PROPOSED GARAGE

JOB TITLE		DRAWING TITLE	
BRAMBLESIDE FELCOT ROAD FURNACE WOOD FELBRIDGE EAST GRINSTEAD RH19 2PX		PROPOSED GARAGE PLANS AND ELEVATIONS	
SCALE	DRAWING NUMBER	REVISION	
DATE: JUNE 2025	PL01 001	-01

PROPOSED GARAGE FLOOR PLAN
REVISED TO 6m X 6m INTERNAL

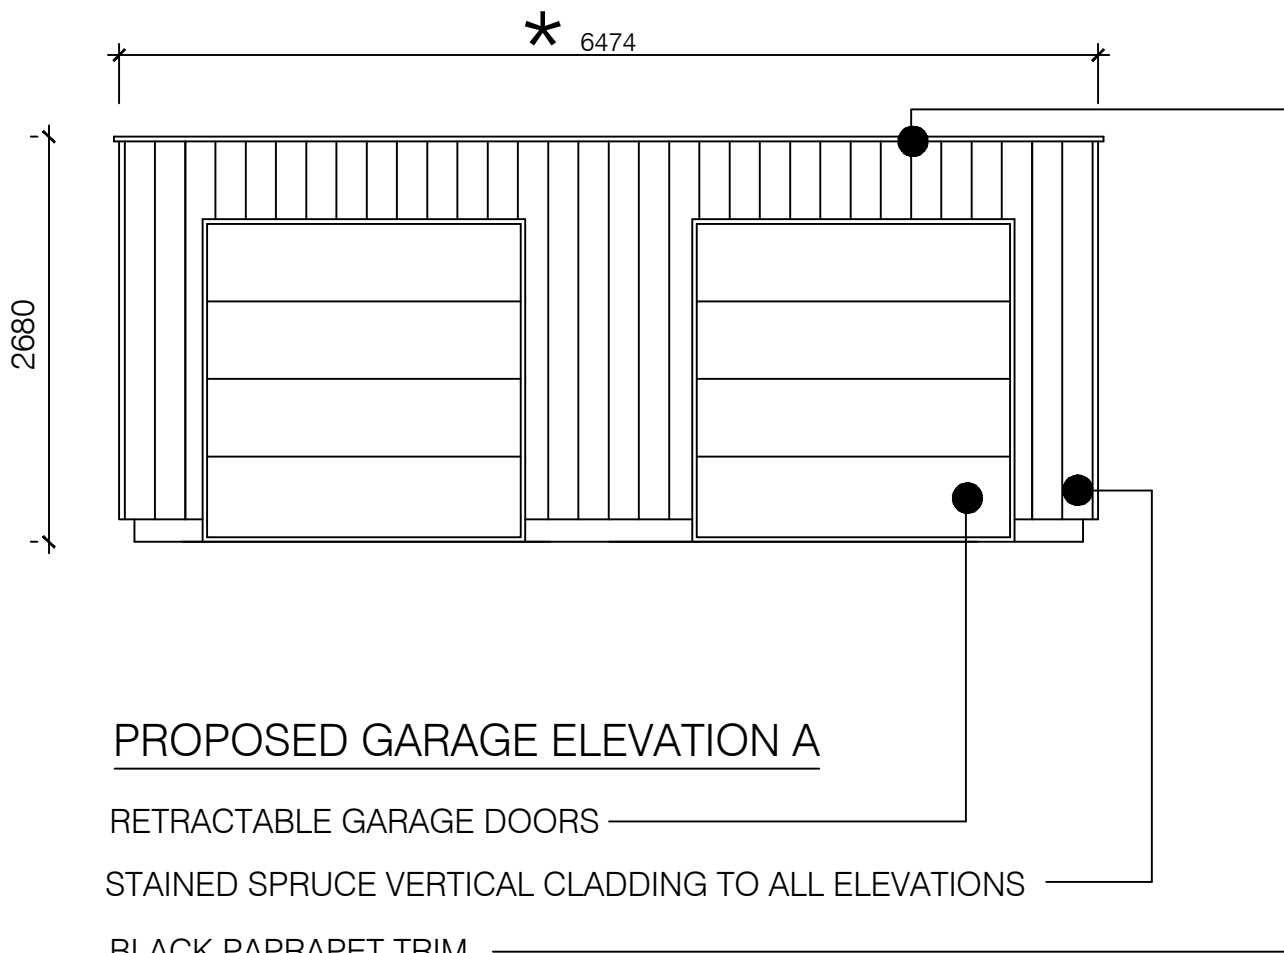
REVISION A: JULY 2025	REDUCE SIZE AND LOCATION OF GARAGE IN LINE OF PLANNING OFFICER COMMENTS
REVISION B: JULY 2025	INTERNAL GARAGE DIMS ALTERED TO MEET MIN REQUIREMENTS
DRAWING CHANGES DENOTED WITH *
